Project
6BKD1
Willmott Dixon

Drawing
Planting Plan East

Project ID	Originator	Zone	Level	Type	Role	Number
6BKD1	- RYD	- ZZ	- XX	- DR	- L	- 70003

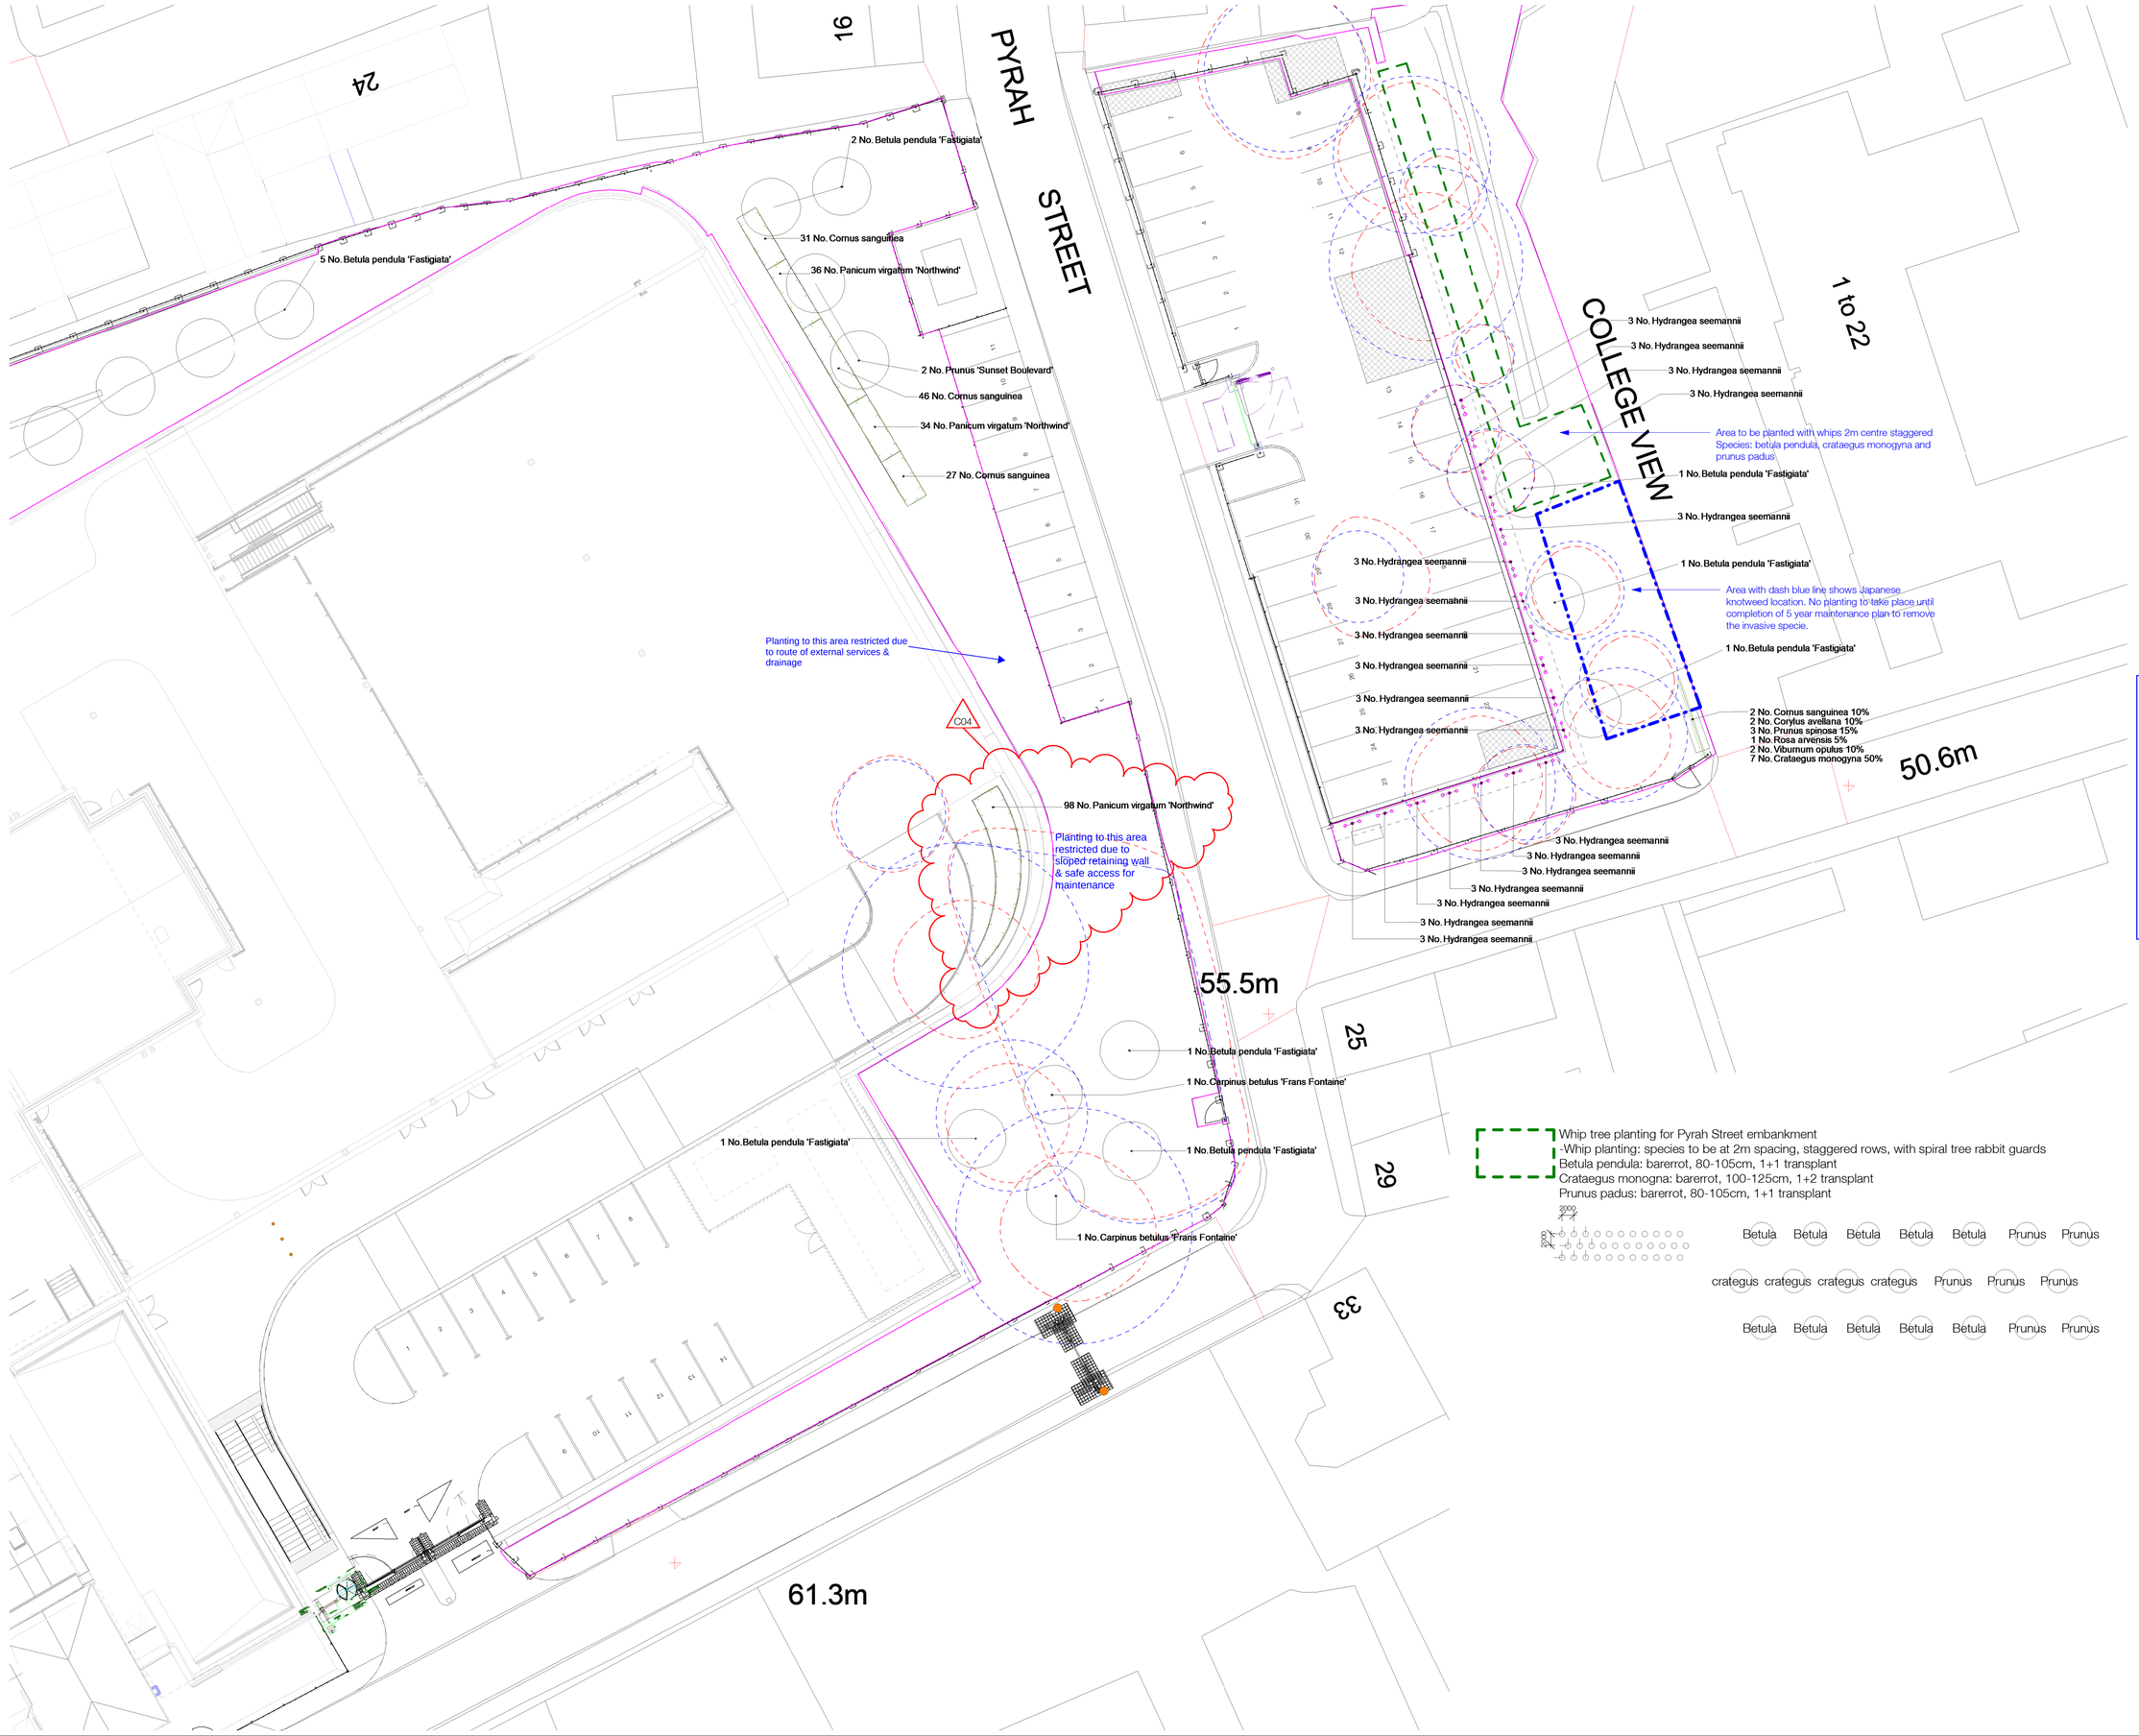
Principal Designer MSCP Planter comments:
After reviewing the initial design which positioned the 1100mm planter tight to the balustrade, there was a distinct concern with how this could aid potential falls from height, as well as create further maintenance issues due to the inaccessible gap between the planter and balustrade.
The solution for this, is to sit the planter circa. 500mm behind the balustrade, tapering it at the south end so that it does not act as a step up over the balustrade. This would still maintain the intention of providing planting to the top of the retaining wall and deflecting car lights from neighbouring premises.
Access for non-roadside maintenance is to be gained from the MSCP. All activities completed by the maintenance contractor are subject to a risk assessment and method statement. Warning signage may be required.
